UNITED STATES PATENT AND TRADEMARK OFFICE

APPLICATION NO.	FILING DATE	FIRST NAMED INVENTOR	ATTORNEY DOCKET NO.	CONFIRMATION NO.
10/629,503	07/29/2003	David M. Mitteer	GRA01 P-418	6730
277	7590	09/22/2006	EXAMINER	
PRICE HENEVELD COOPER DEWITT & LITTON, LLP 695 KENMOOR, S.E. P O BOX 2567 GRAND RAPIDS, MI 49501			KRAUSE, JUSTIN MITCHELL	
			ART UNIT	PAPER NUMBER
			3682

Office Action Summary	Application No. 10/629,503	Applicant(s) MITTEER, DAVID M.	
	Examiner Justin Krause	Art Unit 3682

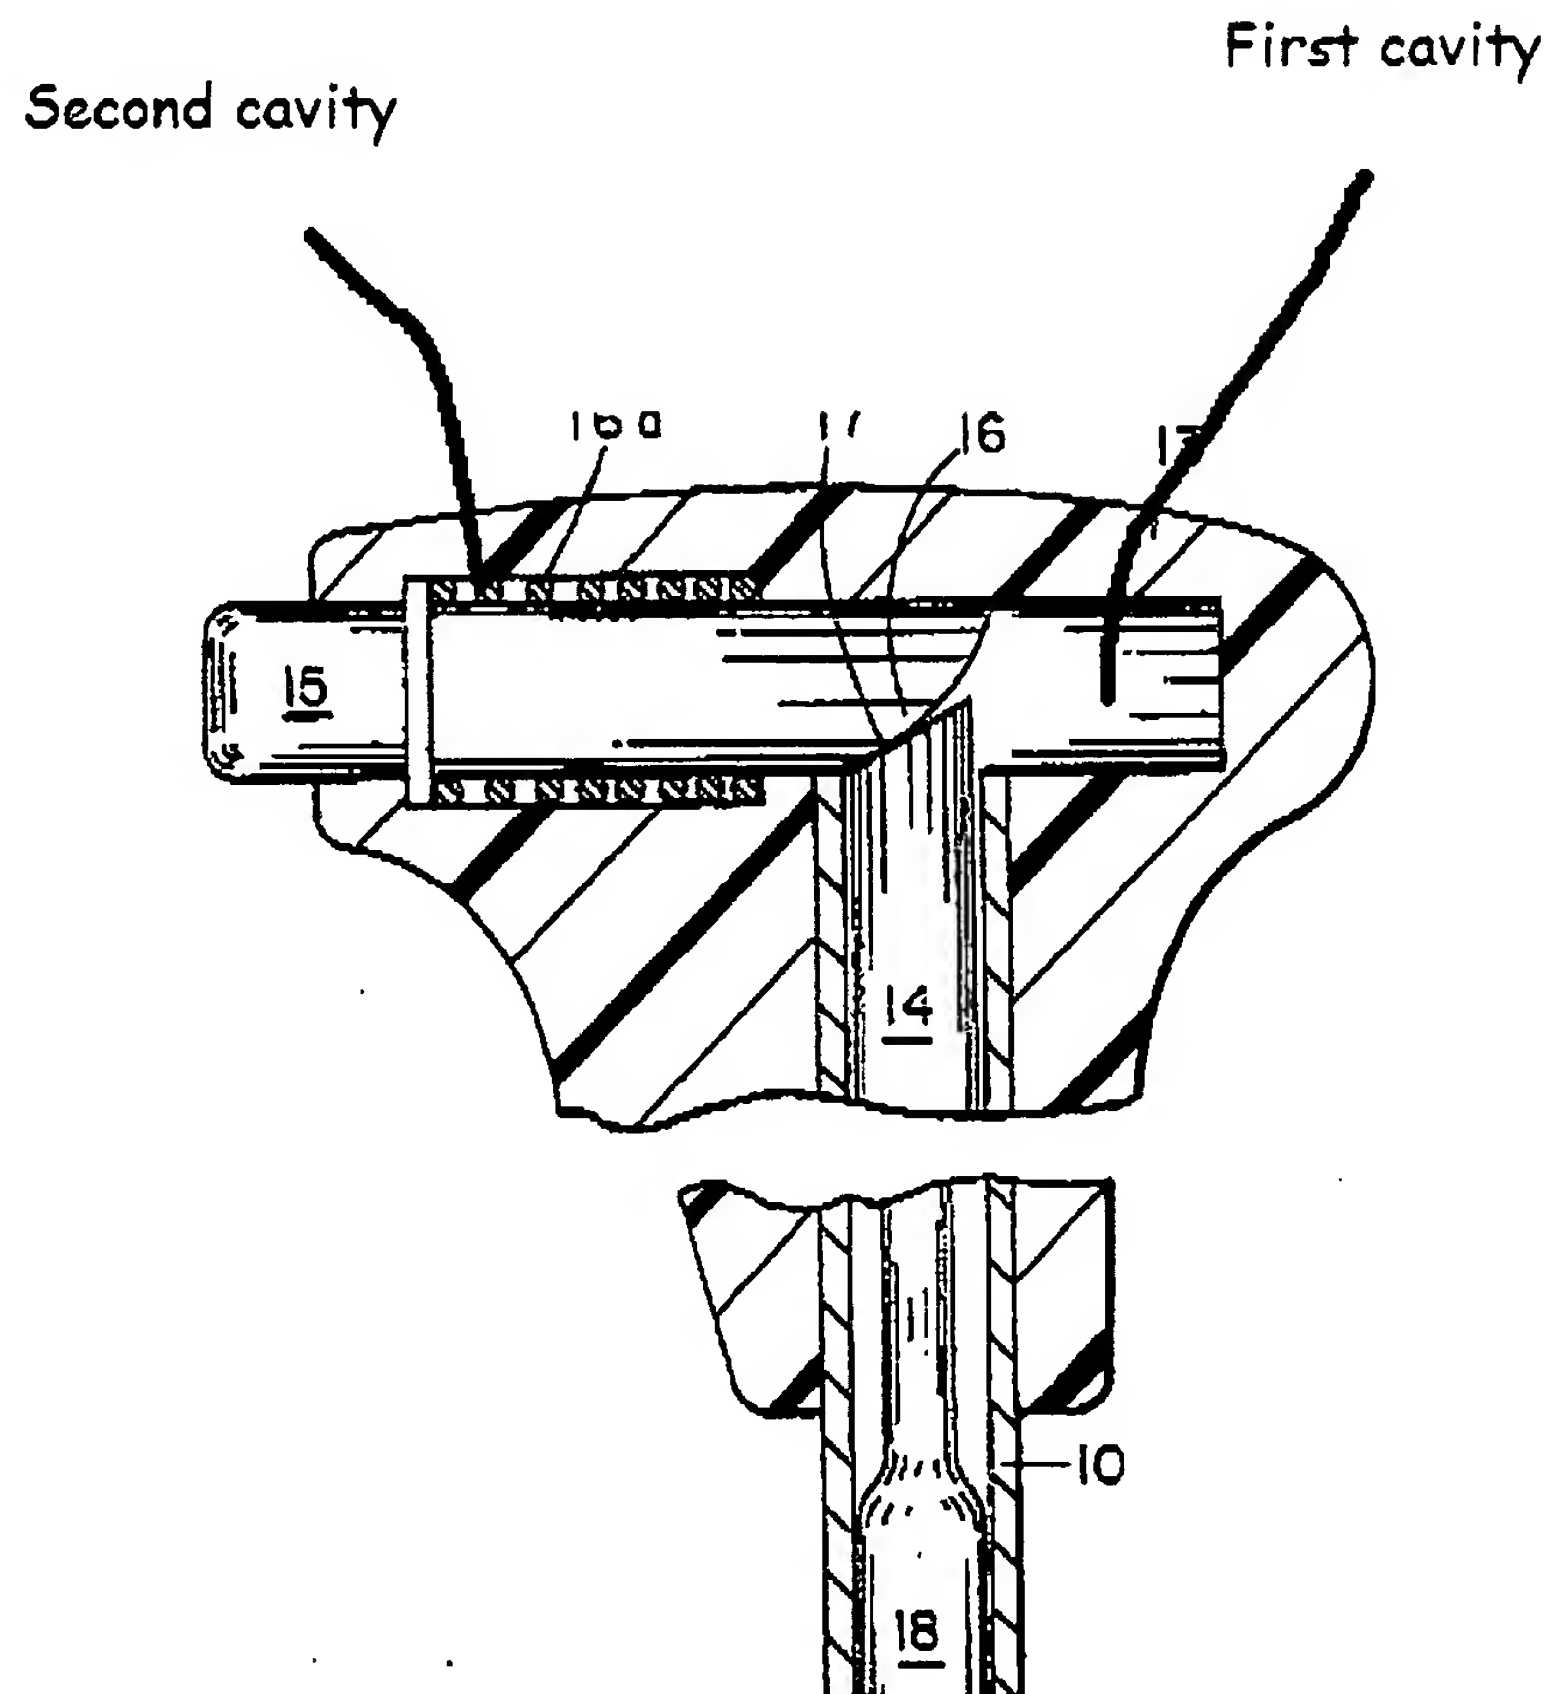
wall of the annular groove, the resilient ring configured to shift within the annular groove to close off the passageway upon movement of the plunger, but Osborn does teach a plunger, as broadly interpreted (16) which has a first end movably disposed in the cavity.

Hiramoto teaches a plunger (12) having a first end portion (see figure 5, the left side of the drawing is considered the "first end") movably disposed in the cavity, the first end portion including an annular groove (40) defining a base wall, the first end portion having a passageway (52) extending from the annular groove away from the first end portion; and a resilient ring (42) in the annular groove, the resilient ring having an outer peripheral edge sealingly engaging the sidewall, and an inner edge engaging the base wall of the annular groove for the purpose of obtaining satisfactory damping by coping with a change in the load by changing the damping force (col 2, lines 3-5).

Regarding claim 13, the cavity comprises a first cavity having a cylindrical shape defining a first diameter, the knob defining a second cylindrical cavity coaxial with the first cavity and defining a second diameter larger than the first diameter; the plunger including a second cylindrical end portion (in Hiramoto, figure 5, the right side is

considered the "second end portion") slidably disposed in the second cavity. (see figure below)
